S 4.55(1A) MODIFICATION

Doncaster Avenue, Kensington

This report has been prepared by Urbis on behalf of Next Constructions Pty Ltd (the 'Applicant') in support of a Section 4.55(1A) application to modify the original State Significant Development (SSD) application SSD 9649 relating to 4-18 Doncaster Avenue, Kensington.

Figure 2 – Approved and Proposed OSD Location

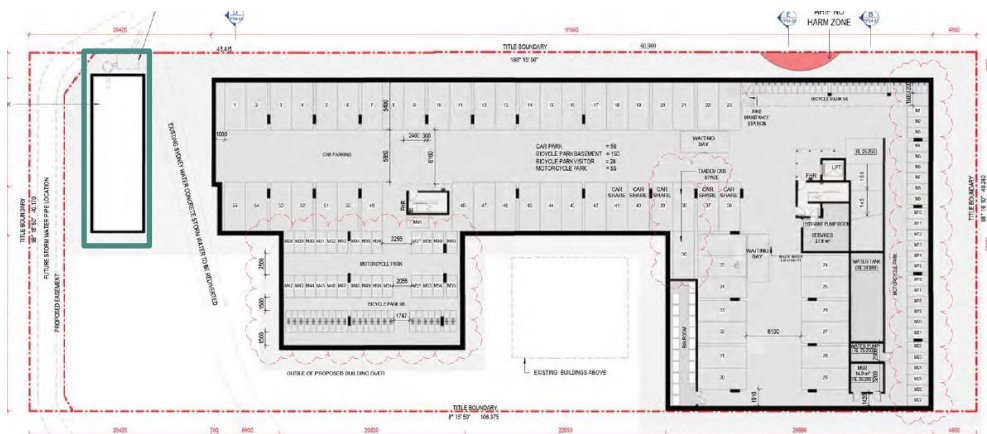
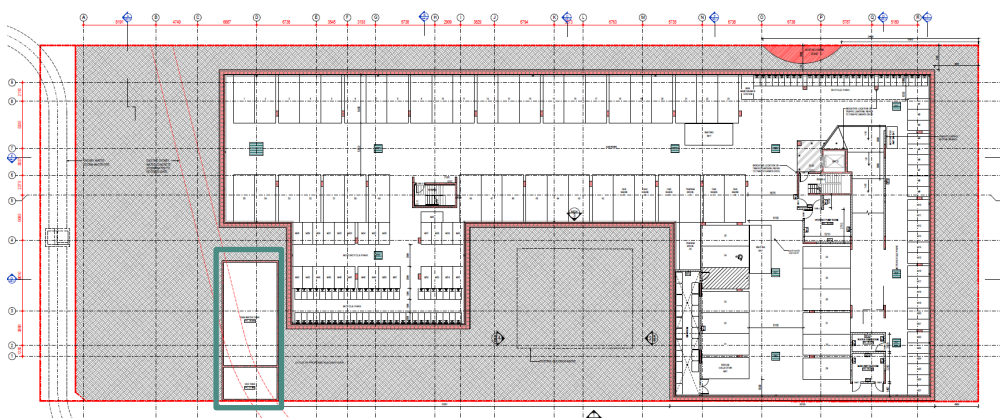
The Section 4.55(1A) modification application seeks to modify the location of the approved OSD tank. Since the development was approved by the Commission, further design analysis has been undertaken by Adams Consulting Engineers, who have determined the current OSD tank must be relocated from its proposed position due to the following issues:

- The location of the approved tank does not allow for water to free flow out of the tank due to the OSD tank discharging against the flow of the diverted Sydney Water Stormwater Culvert. The approved configuration will result in stormwater from the Sydney Water culvert flowing into and filling up and the OSD tank.
- The OSD tank is currently located at highest point of the site and does not allow for internal site stormwater pipes to effectively drain into it.
- The location of the OSD tank is currently located predominantly under the building structure and does not allow for optimum maintenance access.

The approved location of onsite detention tank was based off preliminary advice prior to finalisation of Sydney Water Stormwater Diversion design. Drawings of the existing and revised OSD location are illustrated in **Figure 2** with additional drawings located in **Appendix B** including the approved Sydney Water drawing.
